[Docket No. NHTSA-2010-0015]

### Federal Motor Vehicle Safety Standards; Door Locks and Door Retention Components

**ACTION:** Final rule; response to petitions for reconsideration; technical amendments.

**FIGURE 7 • VEHICLE COORDINATE REFERENCE SYSTEM FOR INERTIAL TESTING**

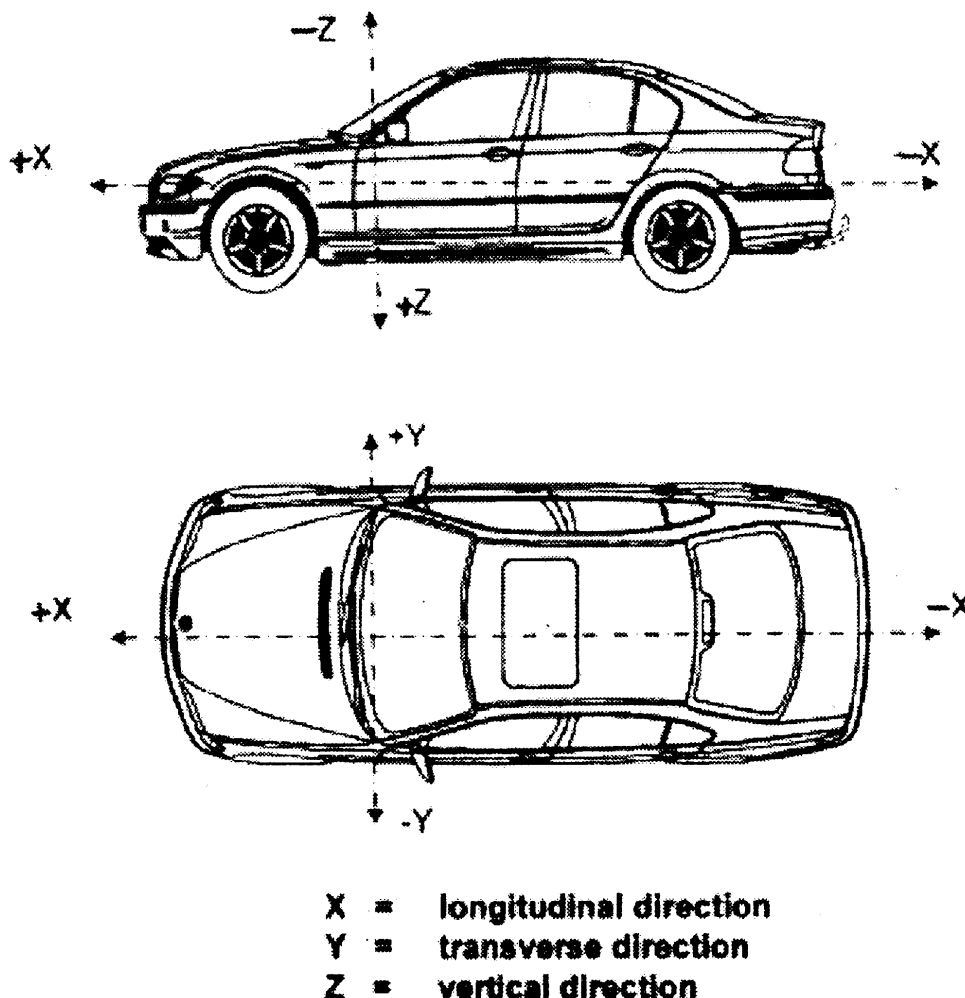
##### *b. Technical Amendment to Figure 7*

Prior to the February 2007 final rule, FMVSS No. 206 did not have a figure that graphically displayed the vehicle coordinate reference system to be used for inertial testing. The GTR provided such a figure because part of the GTR referenced various directions with respect to different vehicle axes. The NPRM proposed, and the February 2007 final rule adopted, this same GTR figure as Figure 7.

Although the agency did not receive any comment regarding Figure 7 in response to both the NPRM and the February 2007 final rule, after publication of the final rule NHTSA realized that x-axis and the z-axis in Figure 7 were not consistent with SAE J211 (Instrumentation for Impact Test) or with the sign conventions used in other Federal motor vehicle safety standards such as FMVSS No. 208 and FMVSS No. 214. Therefore, NHTSA is making a technical amendment to FMVSS No. 206 by modifying Figure 7 to be consistent with SAE J211 and the sign convention for other Federal motor vehicle safety standards as follows:
